**SOIL, GEOLOGY, AND GEOLOGIC HAZARD STUDY  
PARCEL NOS. 43070-00-001 AND 430720-00-015  
WOODMEN ROAD AND HIGHWAY 24  
EL PASO COUNTY, COLORADO**

**Falcon Field, LLC**  
**c/o Springs Engineering, Inc.**  
31 North Tejon Street, Suite 500  
Colorado Springs, Colorado 80903

January 20, 2021

**SITE PLAN TEST BORING LOCATION MAP**  
**FALCON FIELD**  
**HIGHWAY 24 & WOODMEN ROAD**  
**EL PASO COUNTY, CO.**  
**FOR: FALCON FIELD, LLC**

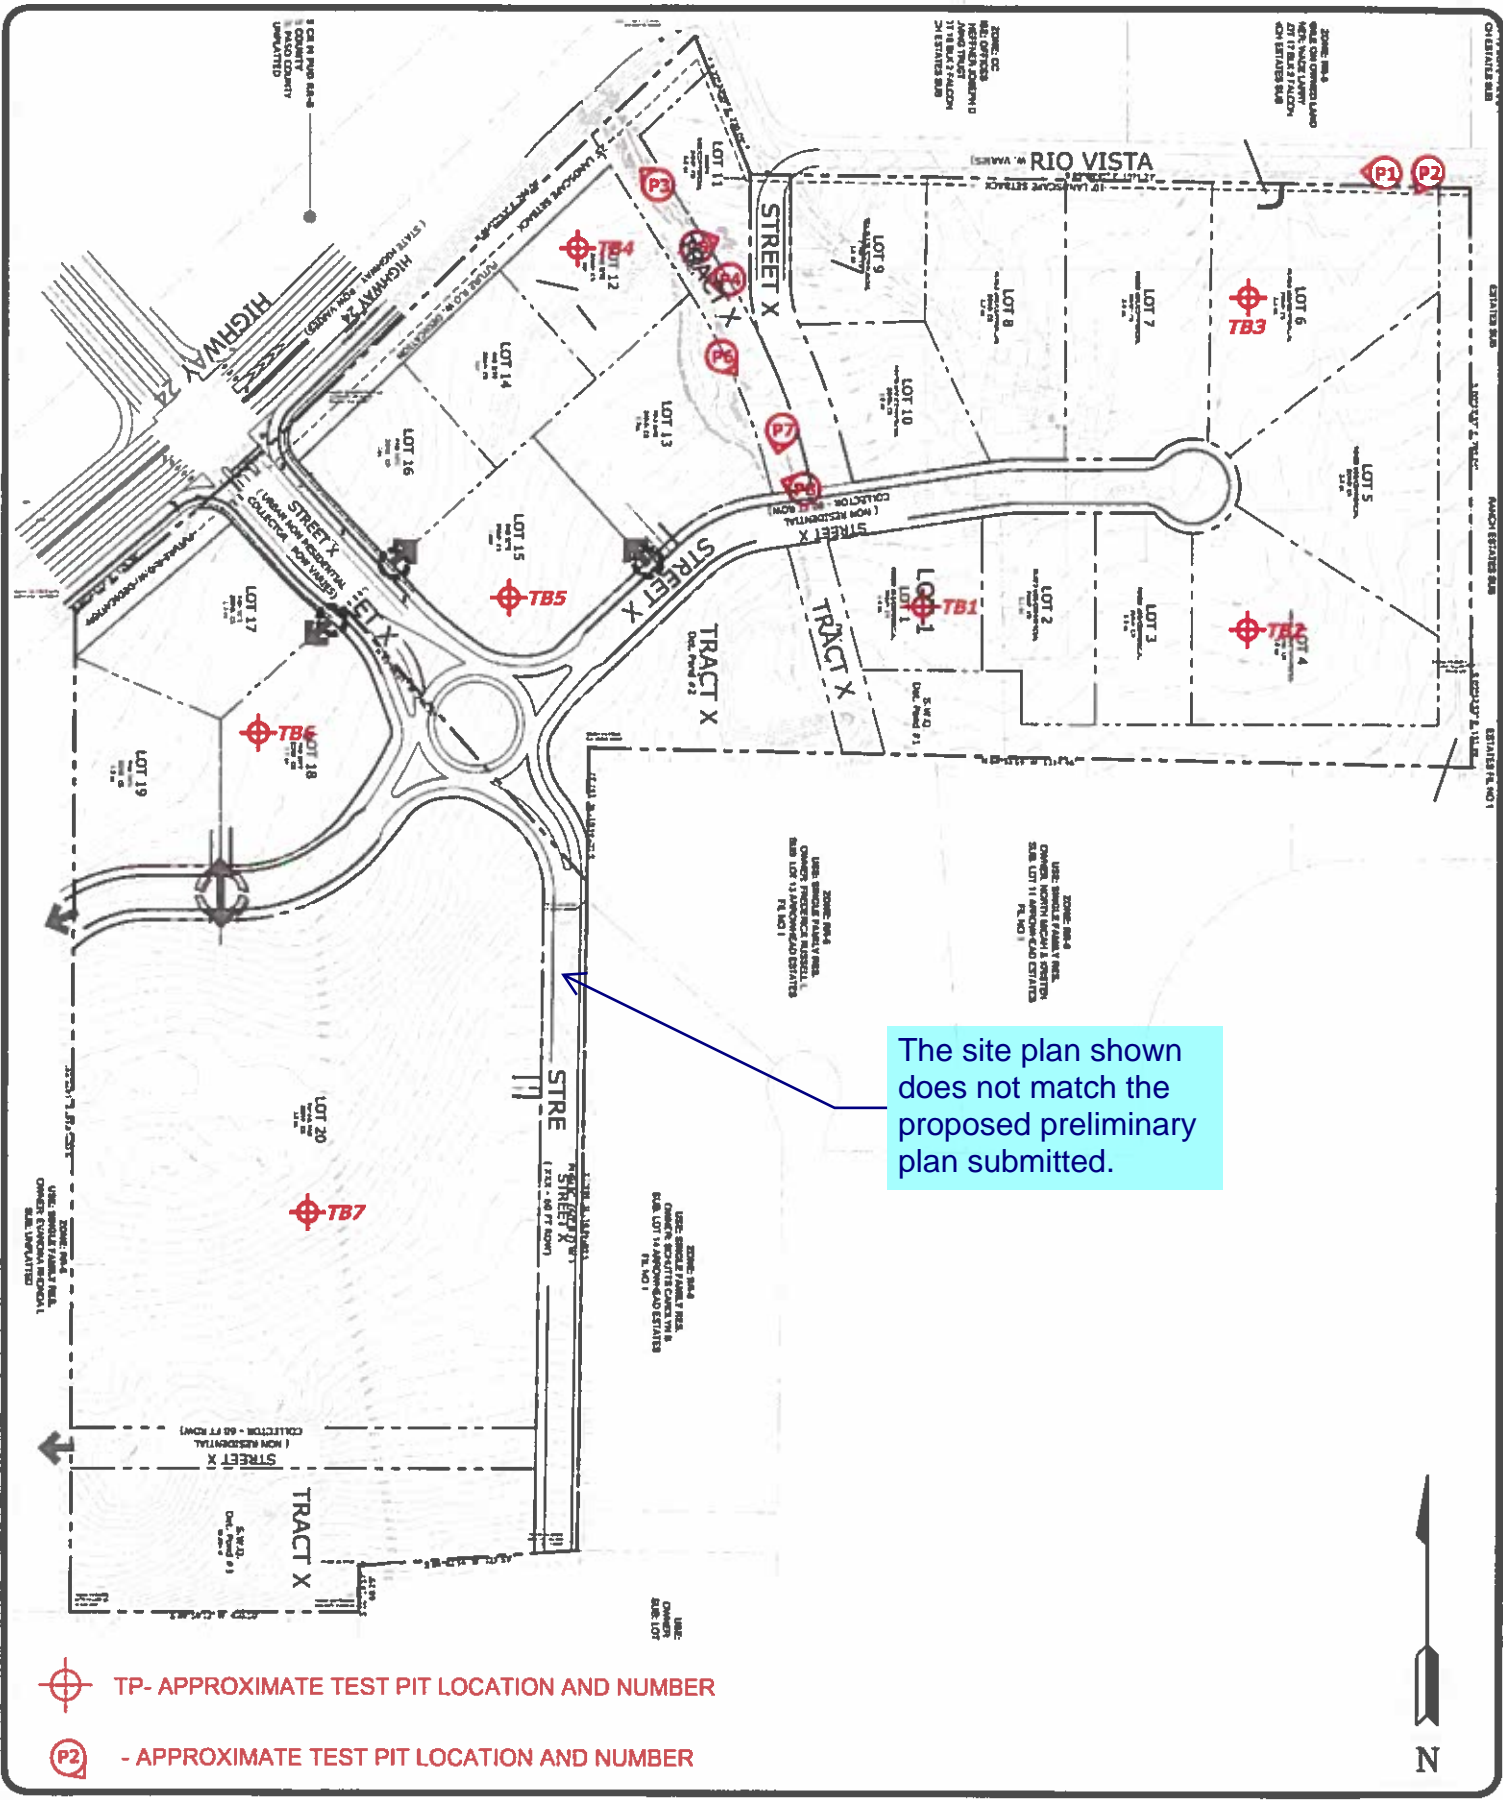
please update to match the currently proposed plan

ENGINEERING GEOLOGY/ GEOLOGY MAP  
FALCON FIELD  
HIGHWAY 24 & WOODMEN ROAD  
EL PASO COUNTY, CO.  
FOR: FALCON FIELD, LLC

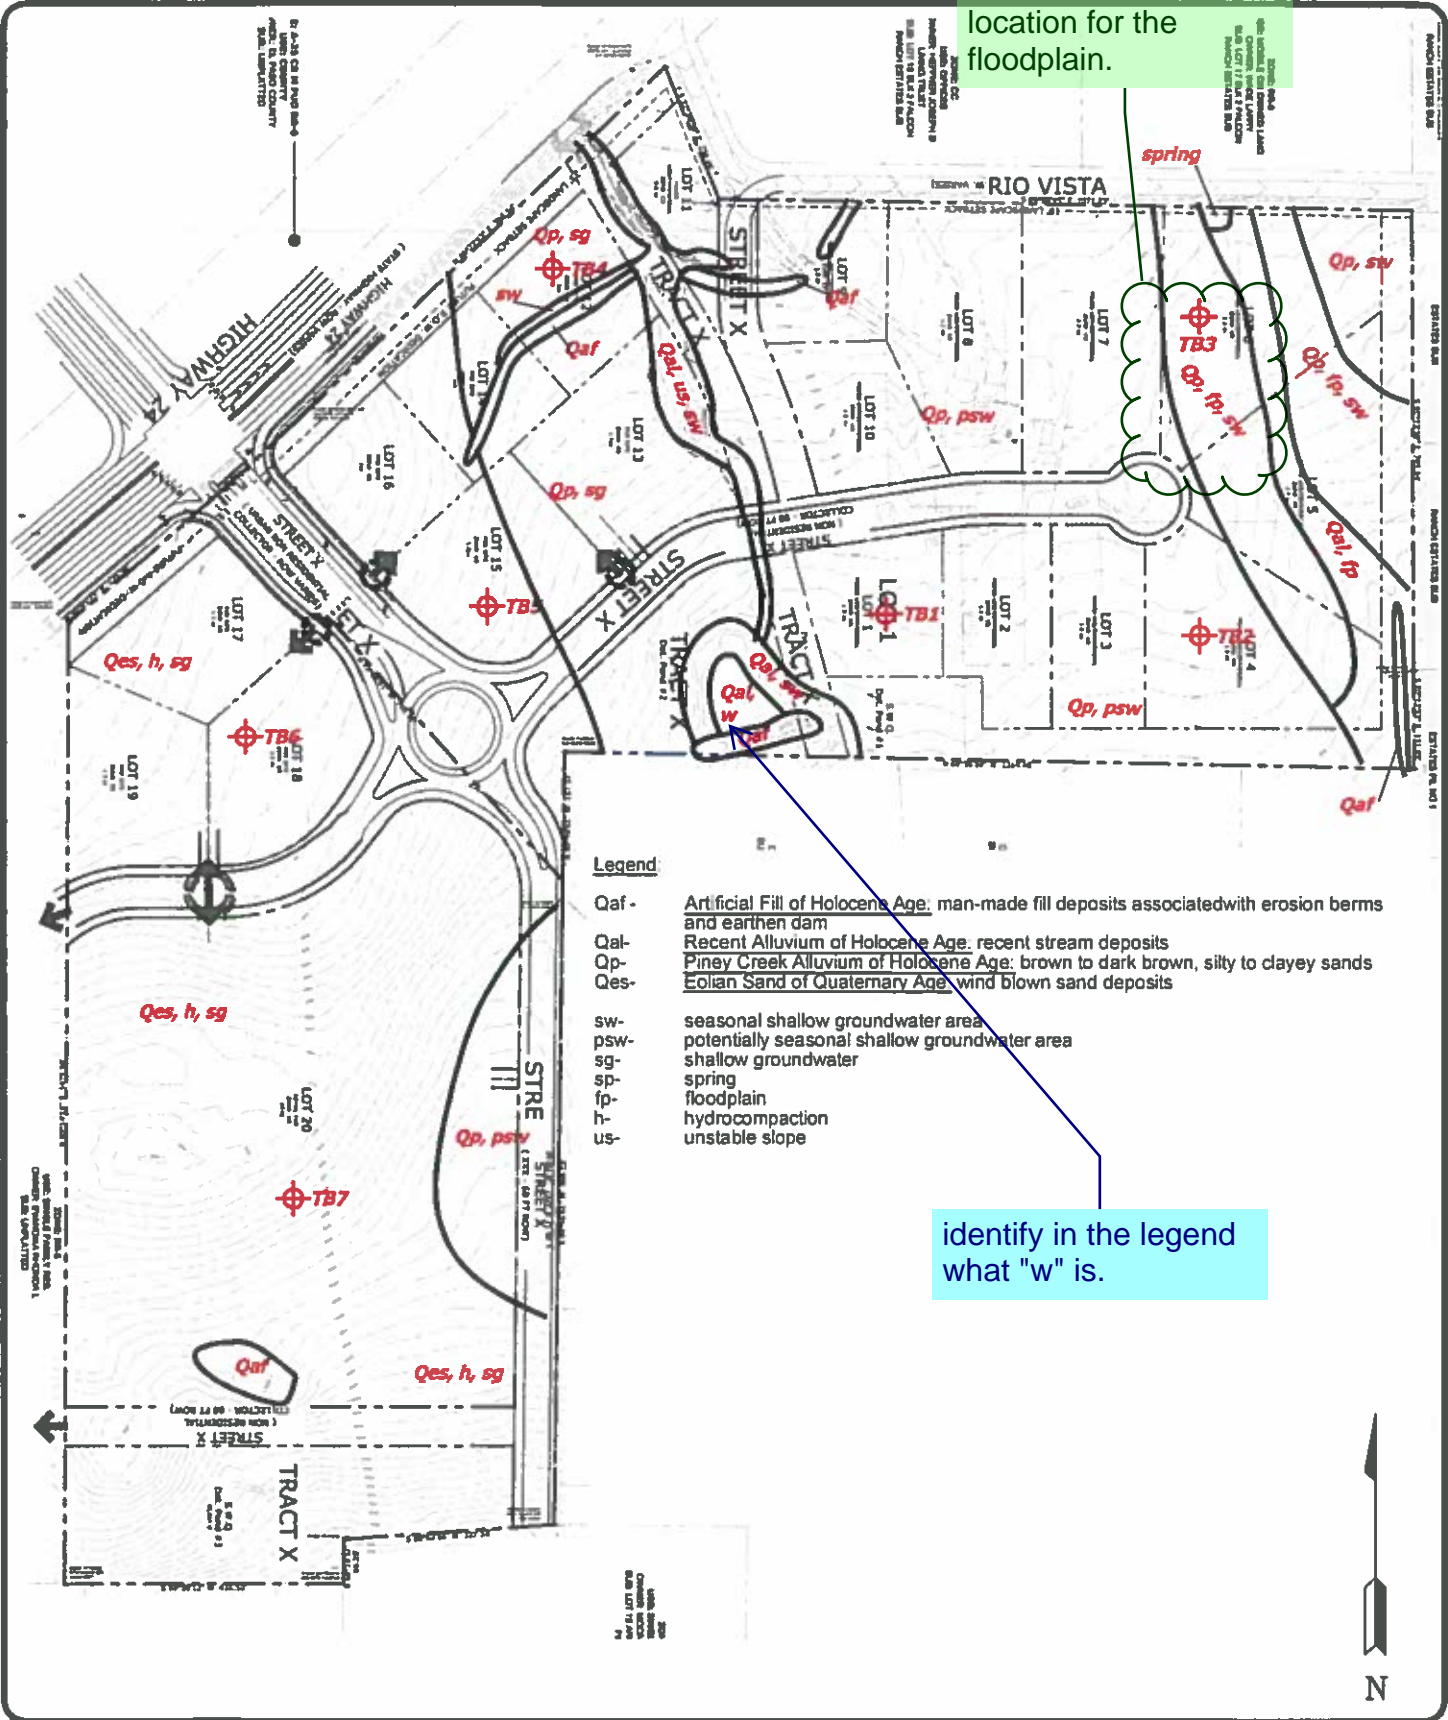
This does not appear to be the correct location for the floodplain.

identify in the legend what "w" is.
